Contract #: 04-0120F4
 Cty: SF/ALA Rte: 80 PM: 13.2/13.9
 File #: 50.25B

QUALITY ASSURANCE -- NON-CONFORMANCE REPORT

Report No: NCR-000647

Description: Partial Height Crossbeam Diaphragm, Piece Mark X27

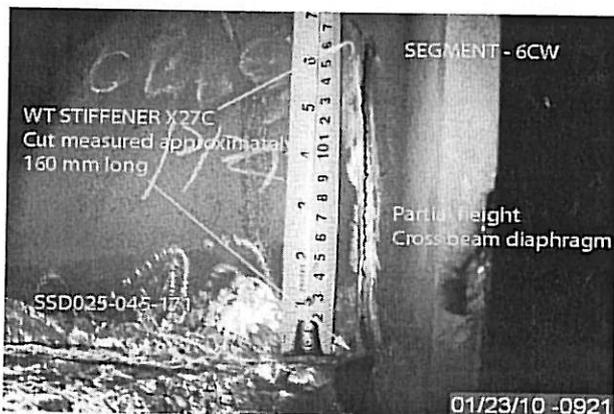
-ZPMC has cut the flange from the web of WT stiffener identified as X27C.

-The stiffener is located on the FL3 floor beam at Panel Point 46.

-The cut measured approximately 160mm in length, perpendicular to Complete Joint Penetration (CJP) weld identified as SSD025-045-171.

-This area will require the addition of a weld that is not designated on the approved shop drawings.

ZPMC acknowledged this problem and has issued internal NCR. The flange was cut to adjust the misalignment with the lower floor beam. ZPMC has repaired the base metal and is providing the NDT records show the repaired area is acceptable. After verification by CT's representative, this issue has been removed from punchlist. ZPMC QA has instructed production department to notify Engineer prior to perform any cutting to base metal. Based on this, ZPMC is requesting this NCR to be closed.

Perform NDT required to verify weld quality.

Contractor issued an internal NCR in regards to this issue. NDT documentation was submitted verifying the quality of the weld complies with Contract specifications.
